Form C-103
Revised July 18, 2013

WELL API NO. 30-015-55125	
5. Indicate Type of Lease STATE ☐ FEE ☒	
6. State Oil & Gas Lease No.	
7. Lease Name or Unit Agreement Name YARDBIRDS 34/3 FEE	
8. Well Number	716H
9. OGRID Number	14744
10. Pool name or Wildcat PURPLE SAGE;WOLFCAMP (GAS)	
11. Elevation (Show whether DR, RKB, RT, GR, etc.) 3043' GR

2. Name of Operator
MEWBOURNE OIL CO

Mewbourne Oil Company requests that the following changes be made to the approved APD for the Yardbirds 34/3 Fee #716H (API: 30-015-55125):

WELL LOCATION AND ACREAGE DEDICATION PLAT

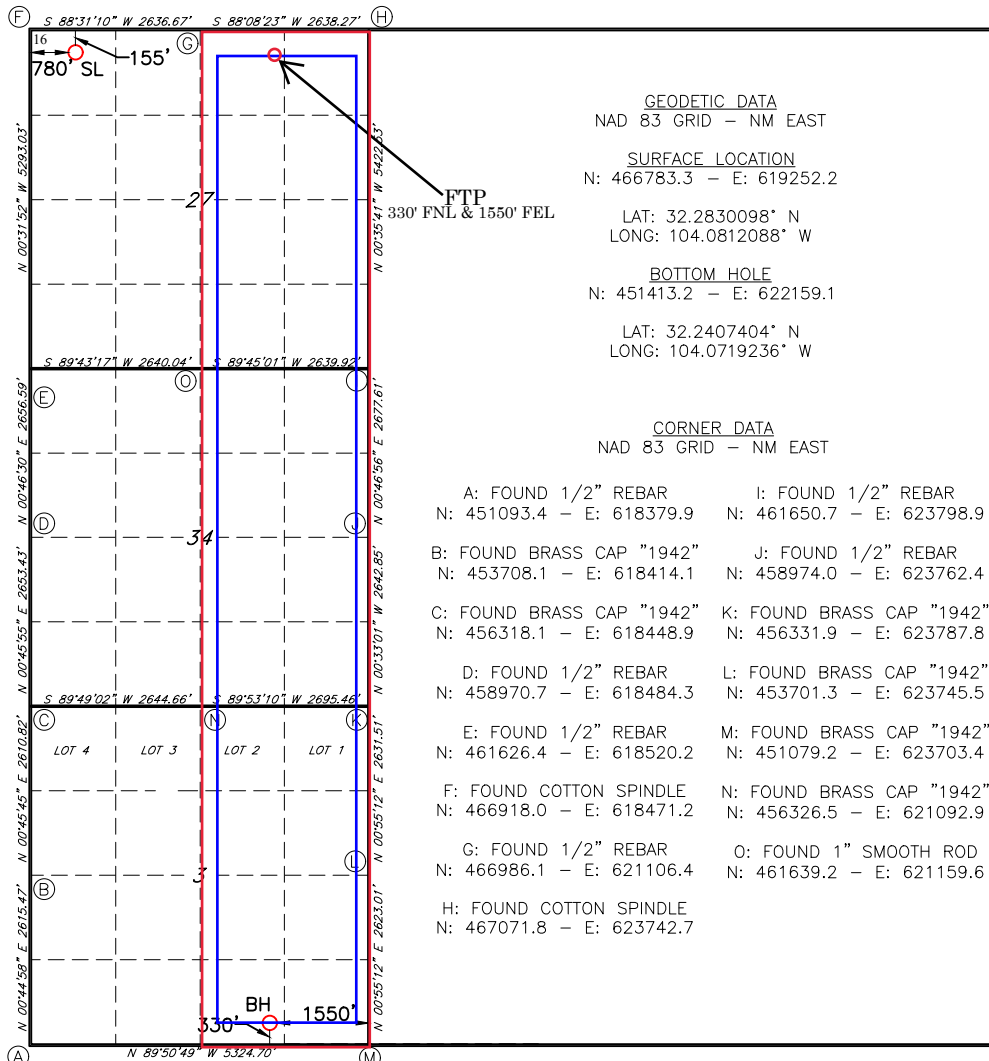
- Change well name from Yardbirds 34/3 Fee #716H to Yardbirds 27/3 Fee #715H.
- Change SHL from 2400' FSL & 1860' FWL (Sec 34) to 155' FNL & 780' FWL (Sec 27).
- Change BHL from 330' FSL & 1480' FEL (Sec 3) to 330' FSL & 1550' FEL (Sec 3).
- Change Surface Casing set depth from 1200' to 450'.
- Change Production Casing from 7" 26# P110 LTC to 7 5/8" 29.7# HCP110 GBCD.
- Change Liner from 4.5" 13.5# P110 LTC to 5.5" P110 Talon.

UL or lot no.	Section	Township	Range	Lot Idn	Feet from the	North/South line	Feet From the	East/West line	County
D	27	23S	28E		155	NORTH	780	WEST	EDDY

UL or lot no.	Section	Township	Range	Lot Idn	Feet from the	North/South line	Feet from the	East/West line	County
0	3	24S	28E		330	SOUTH	1550	EAST	EDDY

Mewbourne Oil Company, Yardbirds 27/3 Fee 716H**Sec 27, T23S, R28E****SHL: 155' FNL 780' FWL (Sec 27)****BHL: 330' FSL 1550' FEL (Sec 3)**

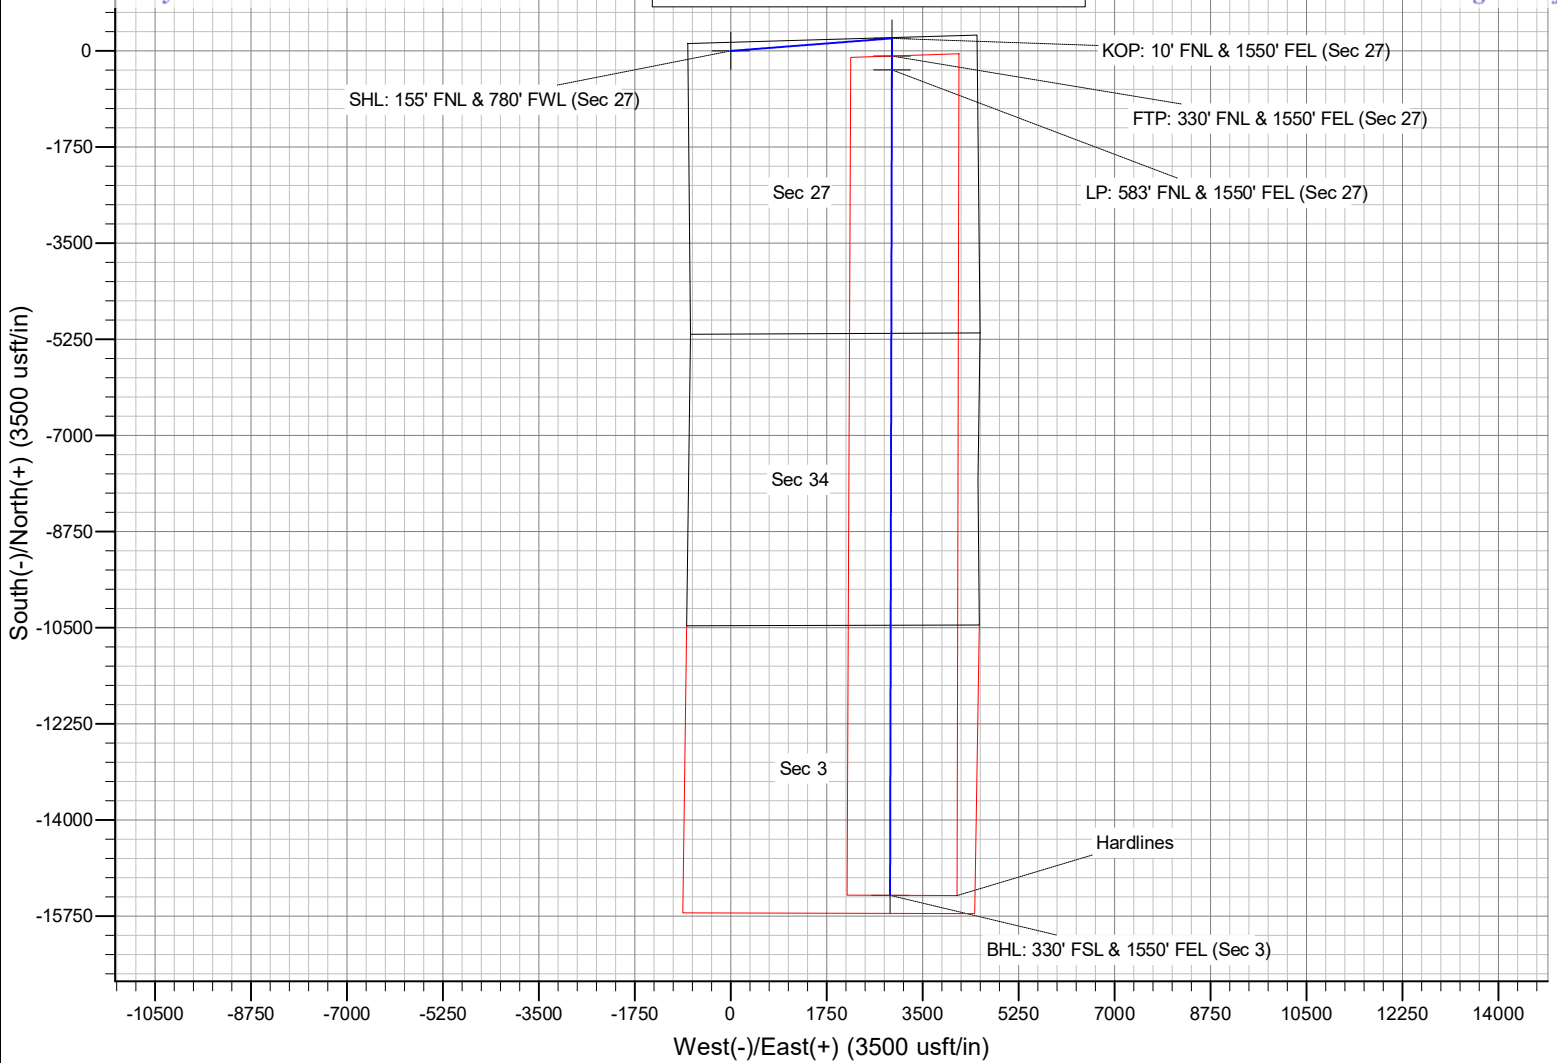
Attached is the C102, Casing Assumptions, Directional Plot and Plan that details the above changes.
